## **Addendum No. 1**

To:  
New Community Building  
Trumann Housing Authority  
Trumann, AR  
April 16, 2024

The Plan holder's attention is hereby directed to the following changes in the drawings and specifications.

**5 One-Line Diagram - NEW**  
 E3.1 NOT TO SCALE

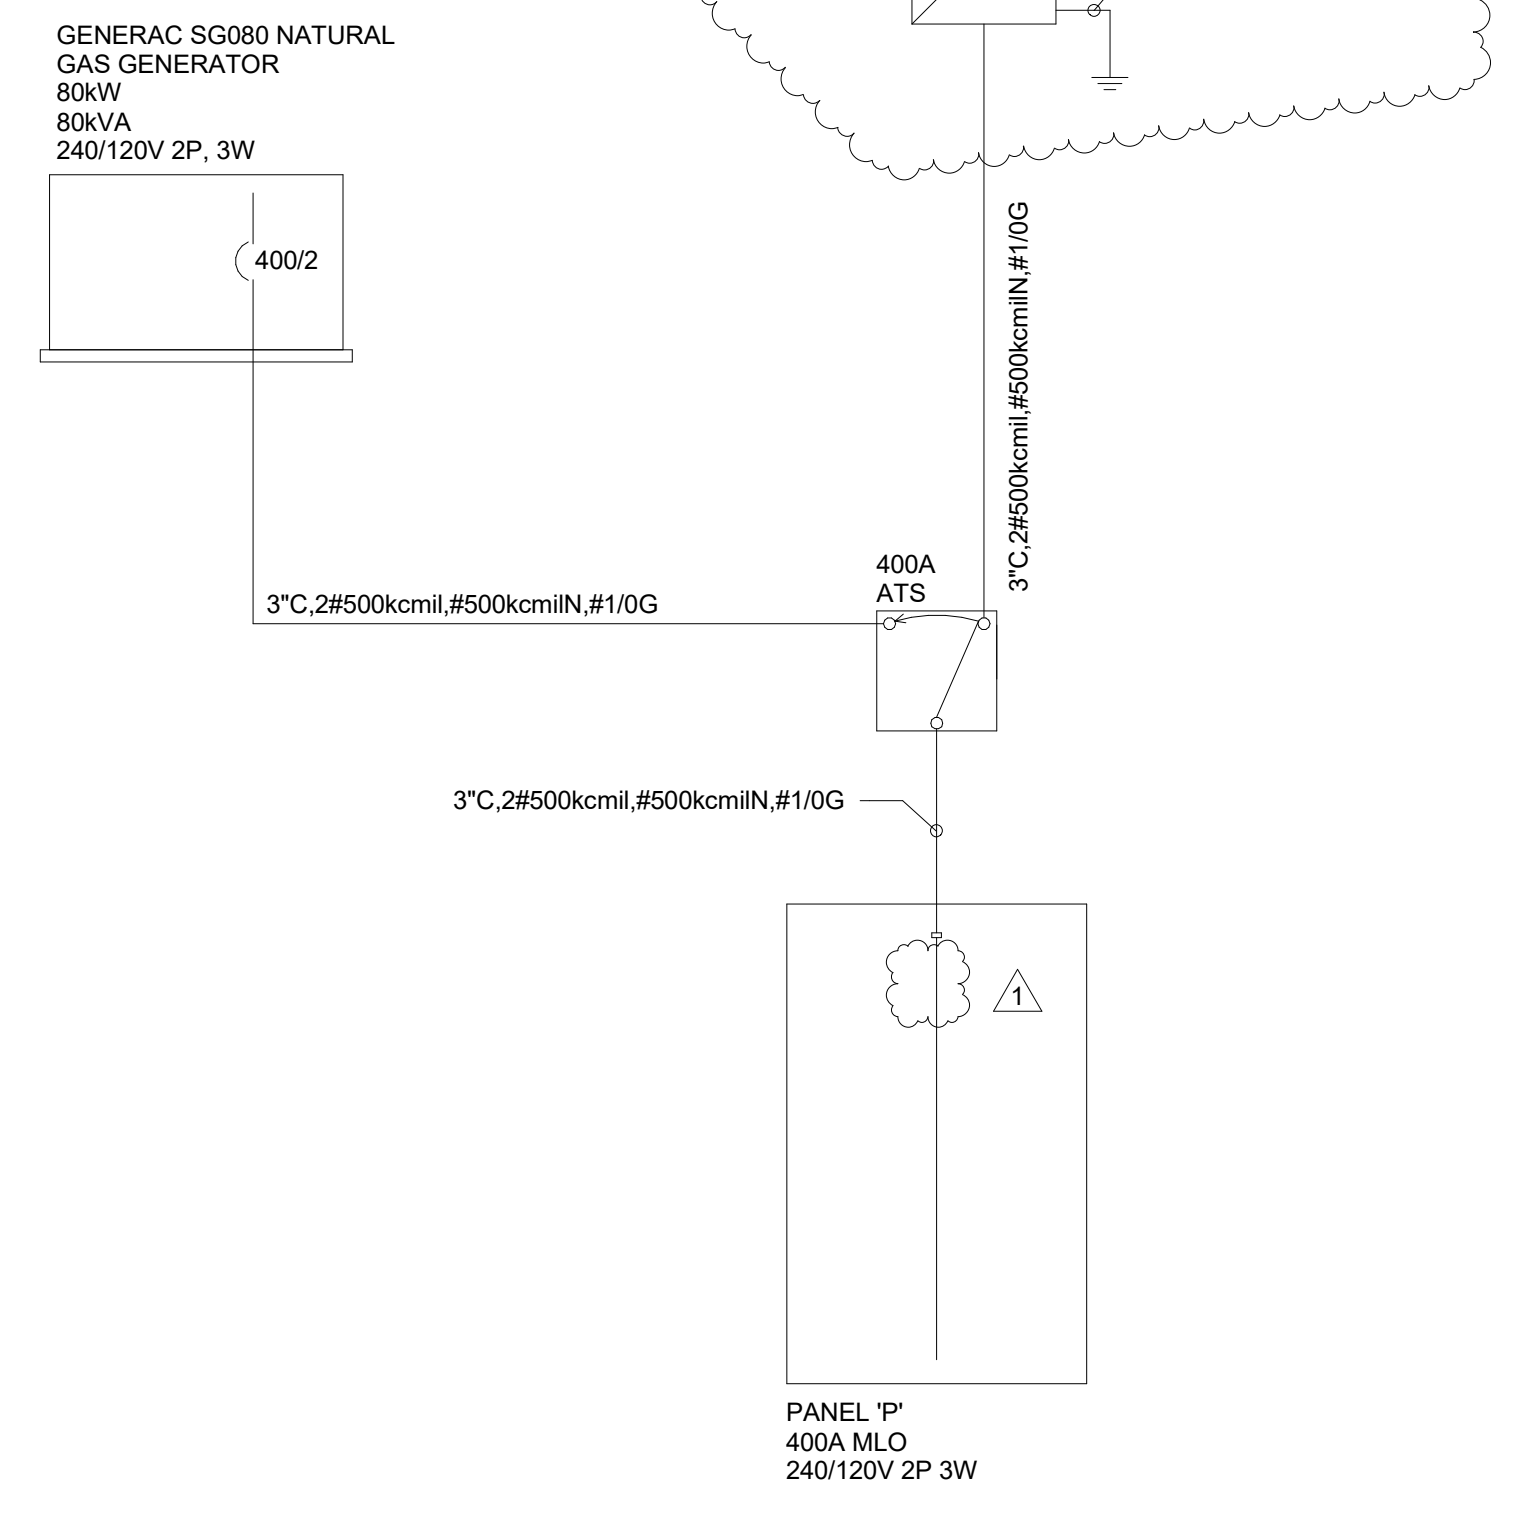
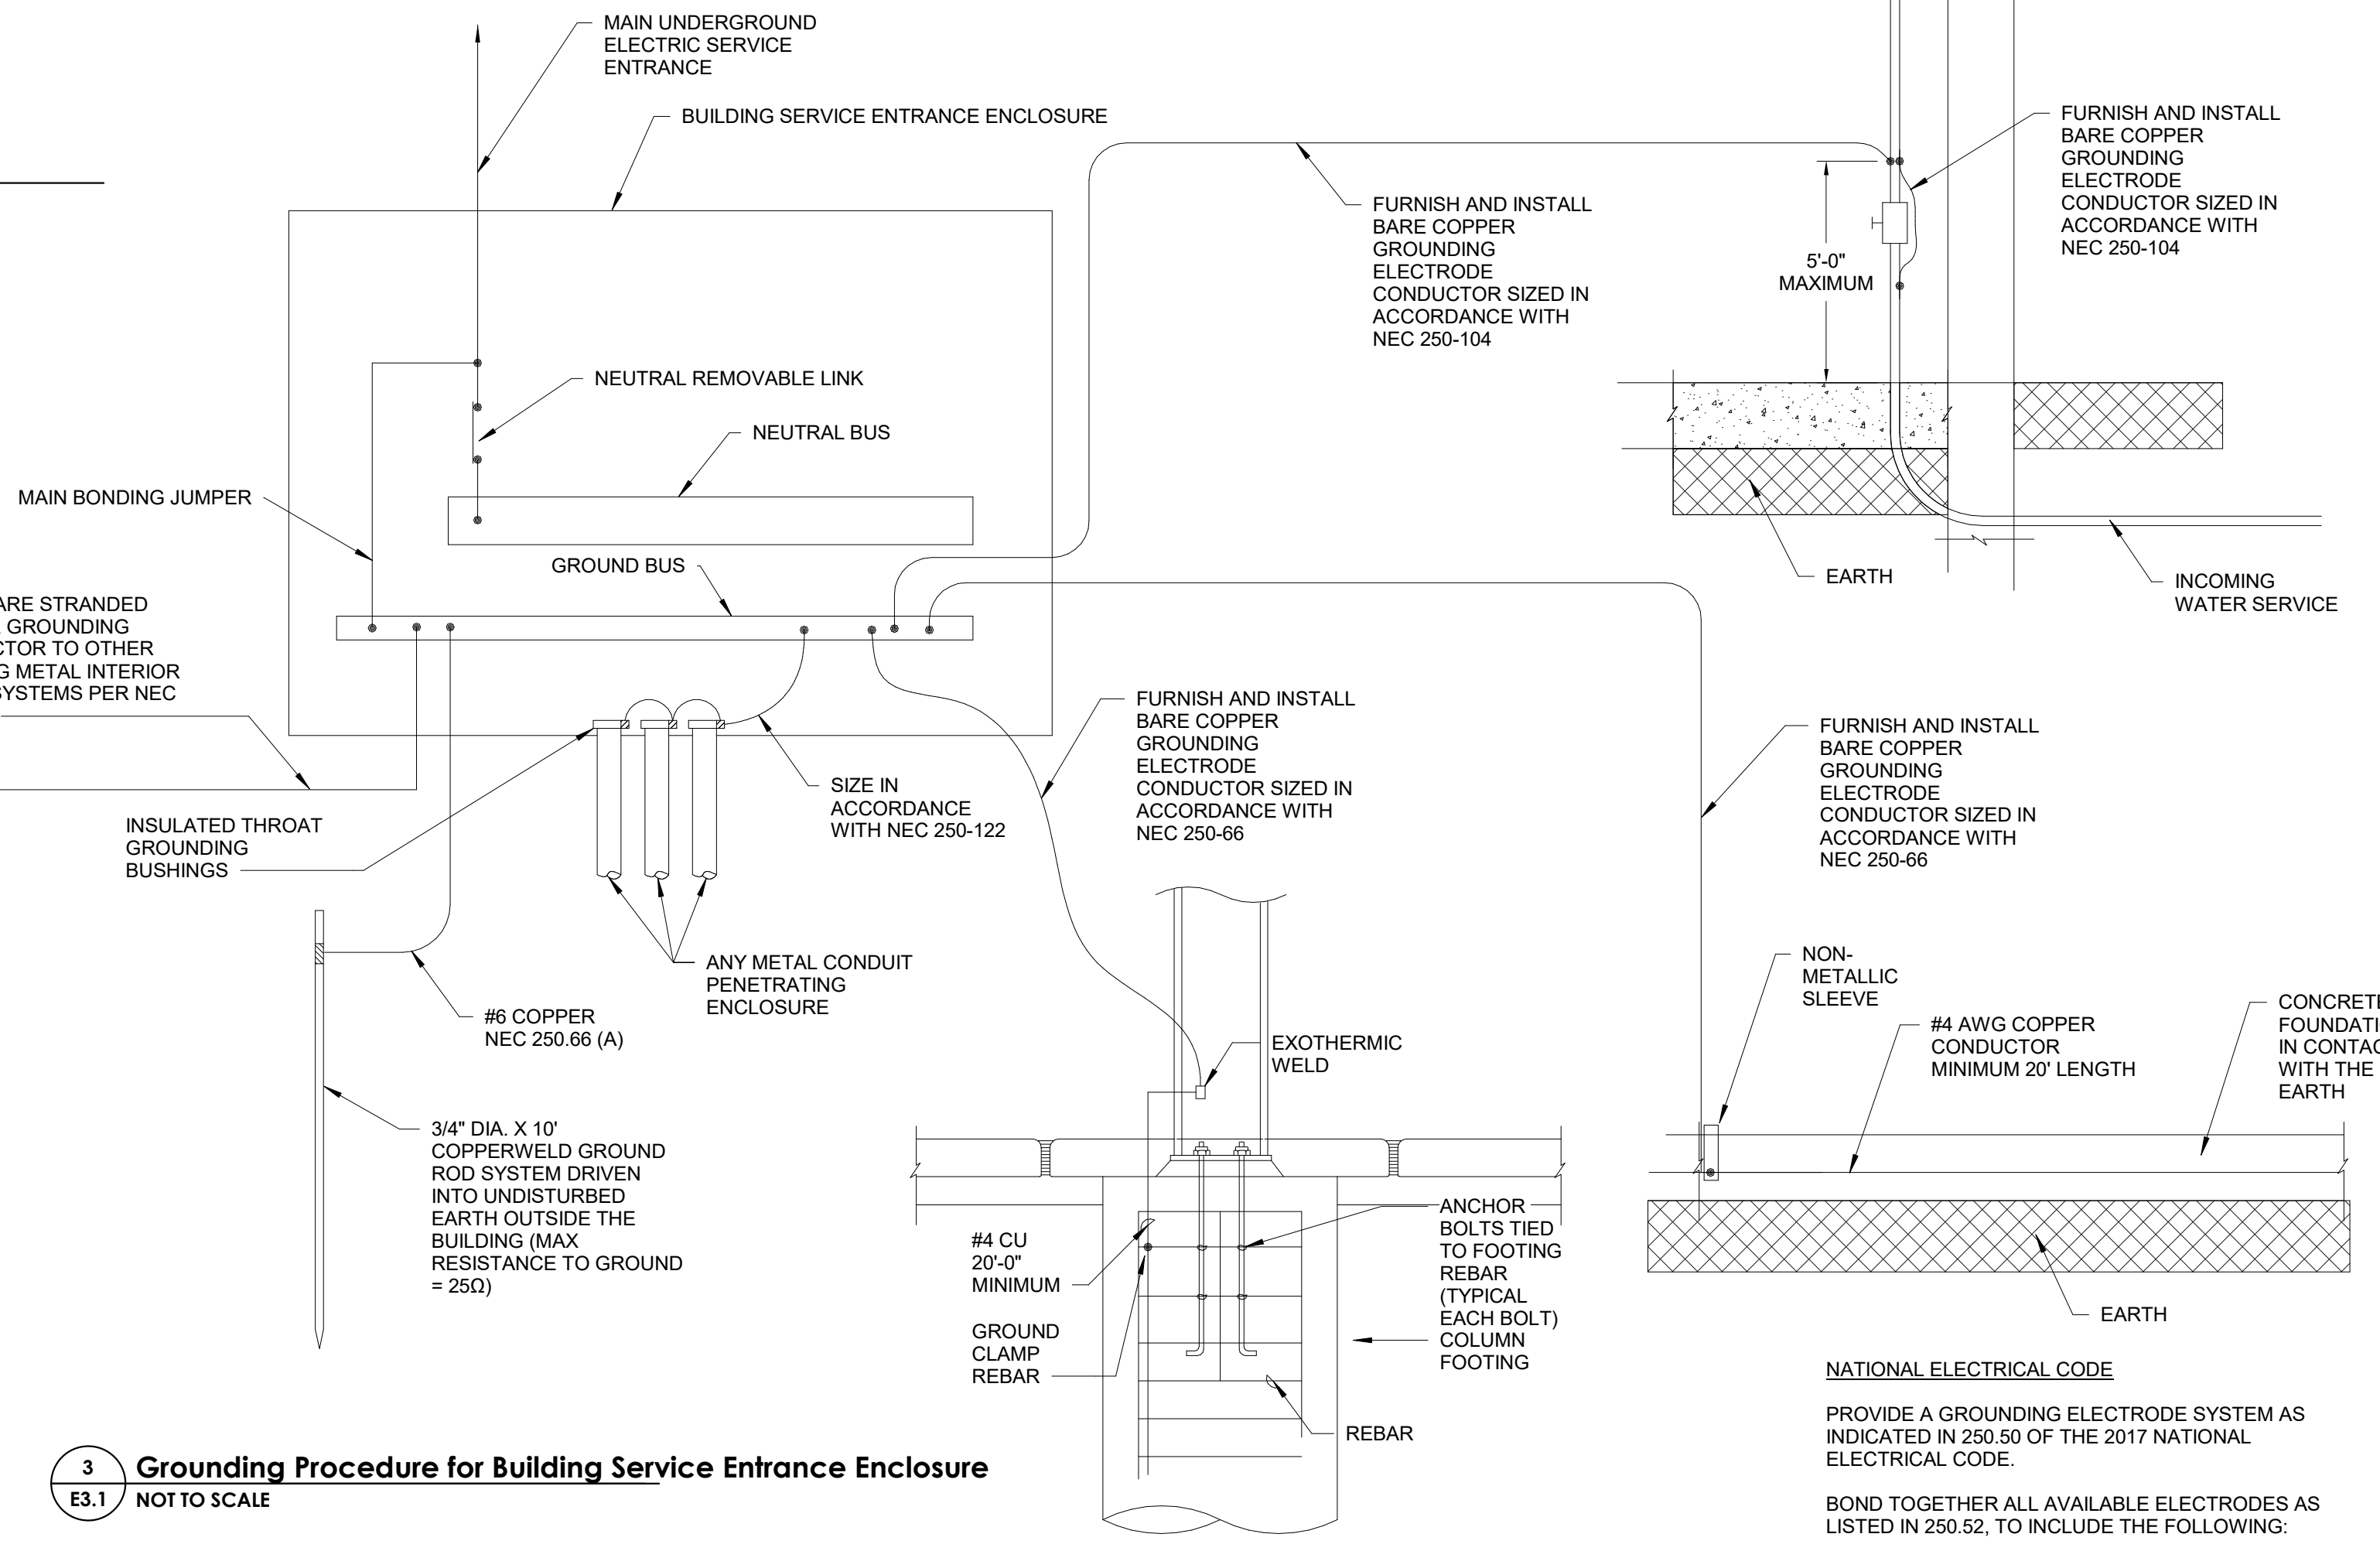
- Item No. 7:** **Revised Drawing:** Electrical Update to outside means of disconnect. (See Attached). Revise the electrical service entrance to provide a fusible disconnect on the building exterior and revise panel P from a main circuit breaker to main lugs only style panel. Refer to updated drawings for location of fusible disconnect.
